OPTIONAL SERVICE BULLETIN

OSB 42-098

Installation of new power supplies for the taxi- and landing lights.

WI-OSB 42-098

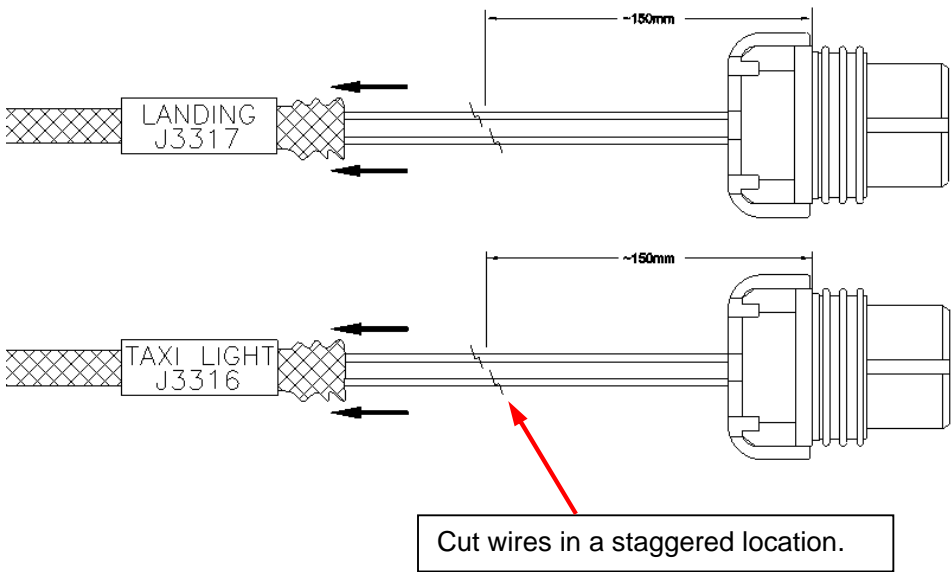
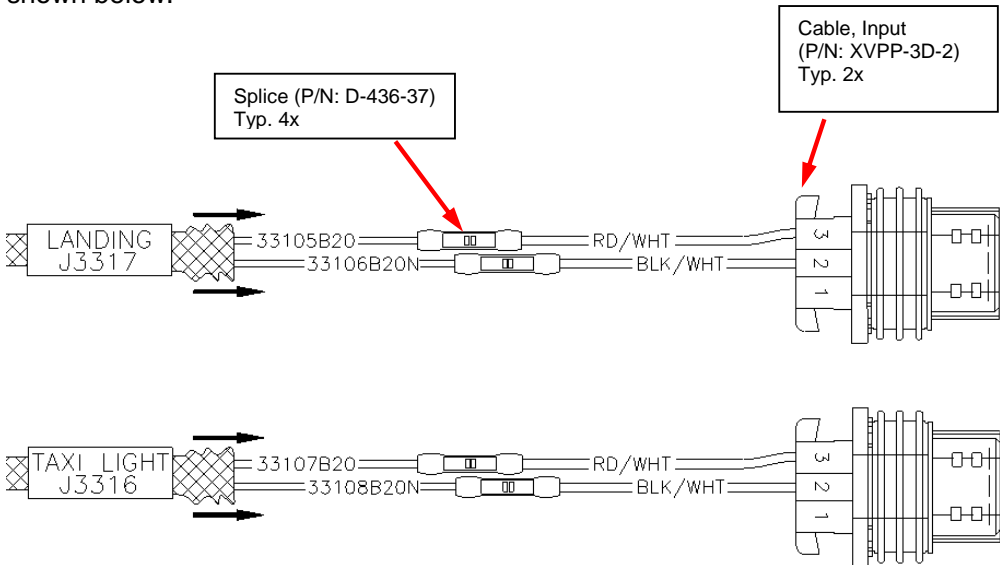
8	<p>Install the new power supplies as shown below.</p> <p>Power Supply: XV4D-24-35-SHS-WT</p> <p>Screw: LN 9037-05 026 Typ. 3x (backside) Washer: DIN 9021-A5.3-A2 Typ. 3x (backside)</p>  <p>Washer: DIN 125-A5.3-A2 Locknut: DIN 985-M5-A2 Typ. 3x</p> <p>Bushing: BU2-15-06-0150-B Typ. 3x</p>
9	<p>Route the new double shielded cable assemblies (P/N: XVLC-2-S) as the previous cables and connect them the power supplies and the taxi- and landing lights. Modification to the structure is necessary to route the connector through it. Make a cutout of 25 mm x 15 mm.</p>
10	<p>Install the taxi- and landing lights i.a.w. AMM Section 33-40.</p>
11	<p>Seal the connector feed through with sealing compound (Easy Gasket or equivalent).</p>
